SUNDRY NOTICES AND REPORTS ON WELLS

8. Well Name and No.
FOX 30 FED COM 701H

EOG Resources requests an amendment to our approved APD for this well to reflect a change casing.

PECOS DISTRICT
DRILLING CONDITIONS OF APPROVAL

Lea County, New Mexico
Proposed Wellbore
Revised 12/5/17
API: 30-025-43867

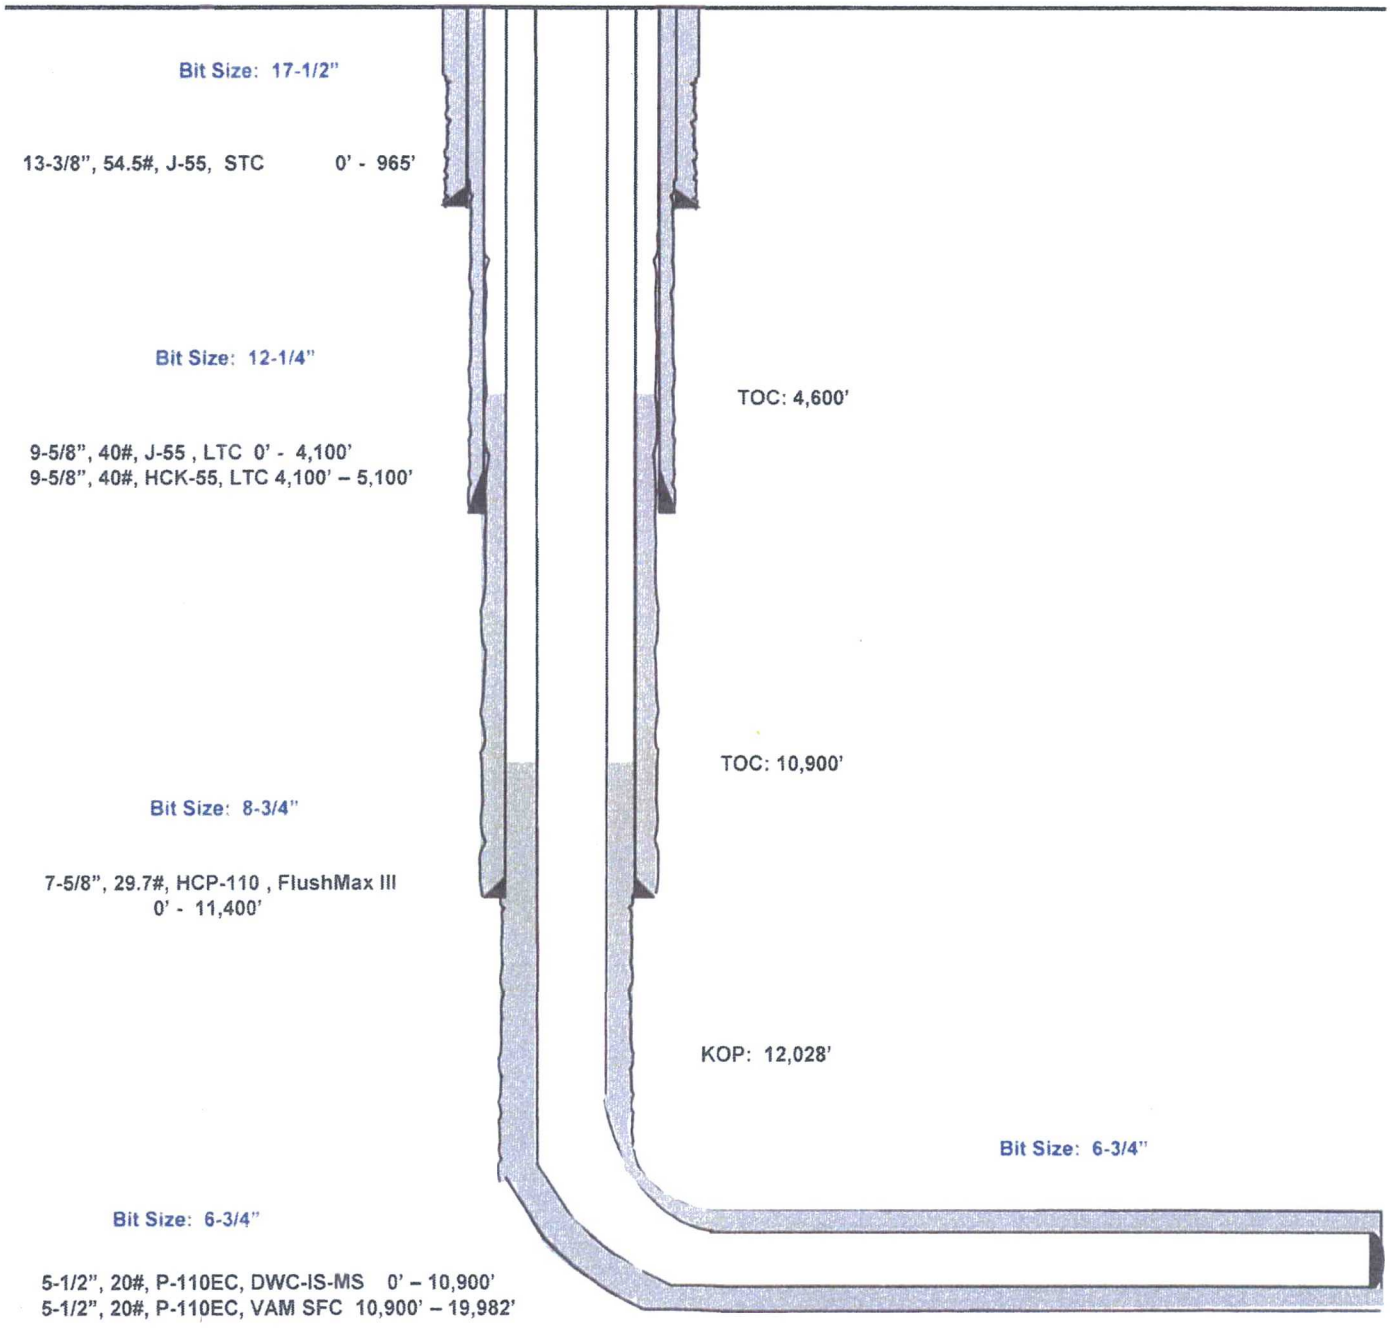
Change to a 4-string casing design as attached.

Operator shall fill 1/3rd of the 2nd intermediate casing with fluid to maintained collapse safety factor. Alterante Brust Safety Factor is also good.

Burst Frac Gradient(s) for Segment(s): A, B, C, D = 0.67, b, c, d <0.70 a Problem!! — ALT. COLLAPSE SF: 0.9*1.5=1.35

1. The **13-3/8** inch surface casing shall be set at approximately **1030** feet (a minimum of 25 feet into the Rustler Anhydrite and above the salt) and cemented to the surface.

2. The minimum required fill of cement behind the **9-5/8** inch **1st** intermediate casing is:Cement to surface. If cement does not circulate see B.1.a, c-d above.

3. The minimum required fill of cement behind the **7-5/8** inch **2nd** intermediate casing is: Cement should tie-back at least 200 feet into previous casing string. Operator shall provide method of verification.

Variance was approved for annular spacing for 5.5 x 7.625 inch casing.

4. The minimum required fill of cement behind the **5-1/2** inch production liner is:
   - Cement should tie-back 200' into the previous casing. Operator shall provide method of verification.
